APPLICATION NO.	FILING DATE	FIRST NAMED INVENTOR	ATTORNEY DOCKET NO.	CONFIRMATION NO.
10/667,056	09/22/2003	Sean McFerran	1001.1708101	7830
28/075 7590 04/27/2010 CROMPTON, SEAGER & TUFTE, LLC 1221 NICOLLET AVENUE SUITE 800 MINNEAPOLIS, MN 55403-2420				
EXAMINER				
GRAY, PHILLIP A				
ART UNIT		PAPER NUMBER		
3767				
MAIL DATE		DELIVERY MODE		
04/27/2010		PAPER

Office Action Summary

DETAILED ACTION

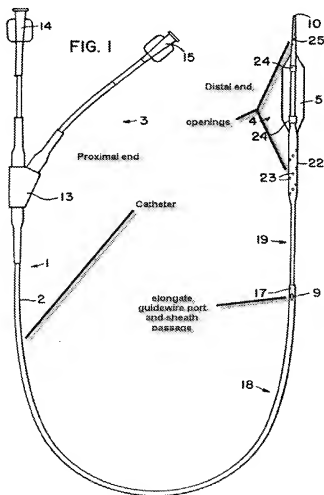
It is examiners position that Allman is not being used to teach the slit length, Pfenninger is discloses this slit length less then the sheath length. Pfenninger shows a slit length less then the sheath length in figure 3 below.

Concerning i) a slit extending at an angle such that the slit has a depth measured from the inner surface to the outer surface of the polymer sheath that is greater than the thickness of the wall of the polymer sheath, both Pfenninger and Allman teach this as would any slit on an angle less than 90 degrees to the outer surface (see Pfenninger figure 3 and Allman figure 4B or 4C).

Concerning the newly added claim language where the slit extends at an angle less than 90 degrees to the outer surface of the sheath again note Pfenninger at figure 3 and Allman at figure 4B and 4C.

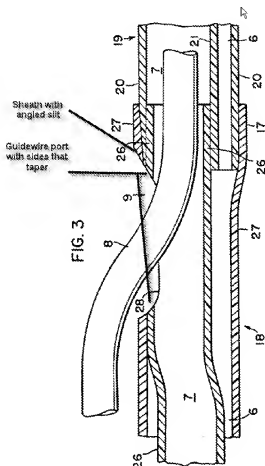
Further note the Sheath (27), angled slit see figure below, guidewire port (near 9 or 28) with tapered walls (see marked up figure 3 below).

Concerning claim 15-16, see near 27 in figure 3.
